27A Lady Somerset Rd,
London, NW5 1TX

Basement Impact Assessment
Audit

For
London Borough of Camden

Project Number: 13693-28
Revision: F1

Figure 8

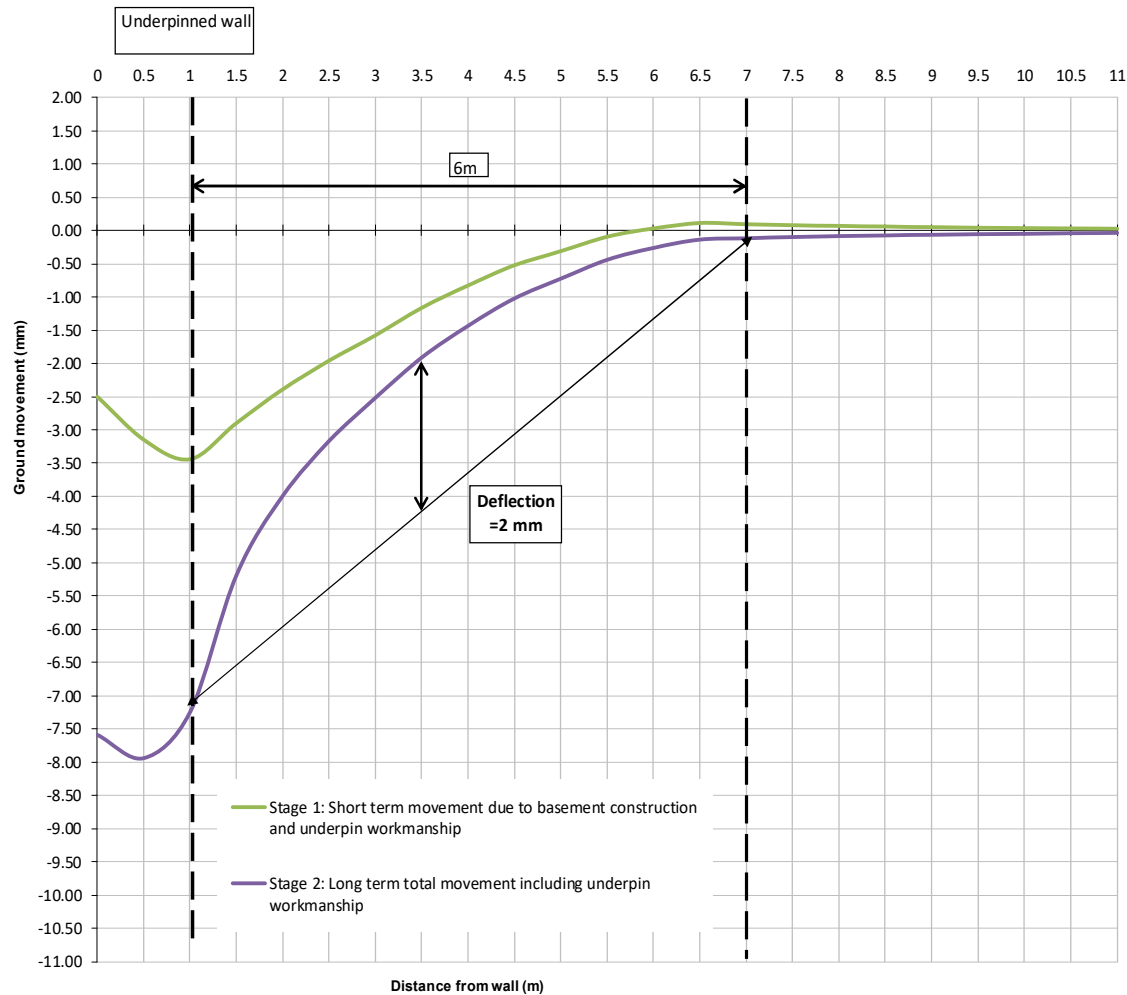
For No.29 Lady Somerset Road, the underpinned party wall, we are calculating 2mm of deflection. A combined ground movement plot for No. 29 is attached. In order to limit to Category 1 damage, we have limited the horizontal strain to 0.058%, by limiting the net horizontal movement/extension of the neighbouring structure to 3.5mm. Our rationale for this is as follows:

1. We assume that 5mm horizontal at the underpin is allowed over a typical excavation depth of ~2m
2. The distance behind the wall to negligible movement can be reasonably taken as ~8m based CIRIA C760 (extract below), and assuming a high (or low) support system.
3. Therefore, the corresponding movement at the rear of the building (~6m away) would be approximately ~1.5mm, therefore the corresponding net horizontal extension of the structure for the purpose of damage category calculations is ~3.5mm.

Please also note that this assessment is already highly conservative, as we have removed all vertical heave from basement unloading in the long term model.

Also based on the above the anticipated maximum horizontal surface deflection would be ~3mm (2m/0.15%), and hence the adopted 5mm is conservative.

Notwithstanding any comments made specifically about the GMA methodology adopted, in summary we would be very concerned if you were unable to demonstrate that predicted damage to neighbouring properties could be kept to Category 1 without reducing you vertical or horizontal movement estimates to <5mm at the wall. This is because managing construction to ensure movements do not exceed these minimum values would be extremely difficult, even with a well managed and comprehensive monitoring strategy.

Reading through your previous responses to Ansaff, it appears that you are currently predicting 3mm of vertical movement at the wall. It was unclear to me whether you are predicting 3.5mm deflection at the wall or whether that is the net change in horizontal strain along the wall being assessed. It would be beneficial if you could attach some calculation outputs with future responses (e.g. contour plots) for clarity.

In regard to the calculations presented, these are accepted and we will close out the BIA audit on that basis. FYI your email below and the attachment will be included within the Appendix 3 of the report for future reference.
